Work Order ID 99388

Item Name: Replacement Skidtube

DRAWING NO. -D2580	TITLE 205 SKIDTUBE ASSEMBLY	REV. E	DART AEROSPACE LTD ENGINEERING ORDER	D.E.O. NO. D2580-E-1	SHEET NO. SHEET 1 OF 1	SCALE NTS
DRAWN <i>UP</i>	CHECKED <i>ASS</i>	MFG. APPR. <i>ER</i>	APPROVED <i>[Signature]</i>	DE APPR. <i>[Signature]</i>		
DATE 11.12.13	DATE 11.12.13	DATE 11.12.13	DATE 11.12.13	DATE 11.12.13

CHANGE ALL C'BORED WELDED CROSSBOLT SPACERS TO SWAGED SPACERS

SECTION B-B, F-F, I-I
NOT TO SCALE

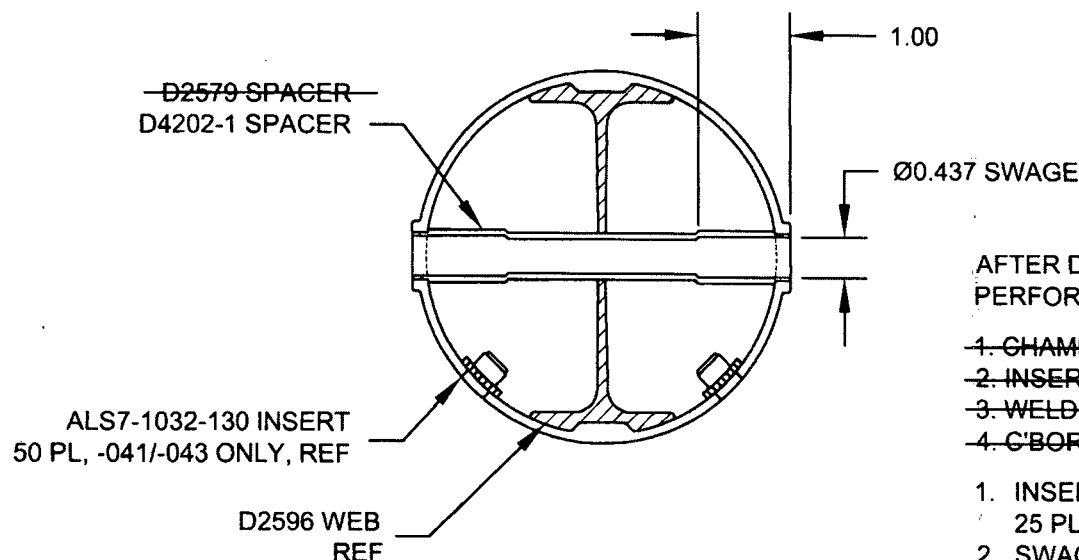
SECTION B-B, SECTION F-F, & SECTION I-I ARE AMENDED AS FOLLOWS FOR ALL HOLES THAT WERE ORIGINALLY C'BORED:

AFTER DRILLING AND BENDING ASSEMBLY
PERFORM THE FOLLOWING FOR Ø0.508 HOLES ONLY:

1. CHAMFER HOLE 0.050 X 45°
2. INSERT D2579 SPACER (20 PLACES)
3. WELD INTO PLACE AND GRIND FLUSH
4. C'BORE D2579 SPACER TO Ø0.437 X 1.00 DEEP

WELD 4X D2579 SPACERS PER DWG IN LOCATIONS MARKED "NO C'BORE".
REF SHEET 4 OF DWG.

1. INSERT D4202-1 SPACER, 20 PL (-041) OR 20 PL (-045) OR 25 PL (-047)
2. SWAGE TO Ø0.437 X 1.00 DEEP PER QSI 002
3. TRIM / GRIND FLUSH PER QSI 002
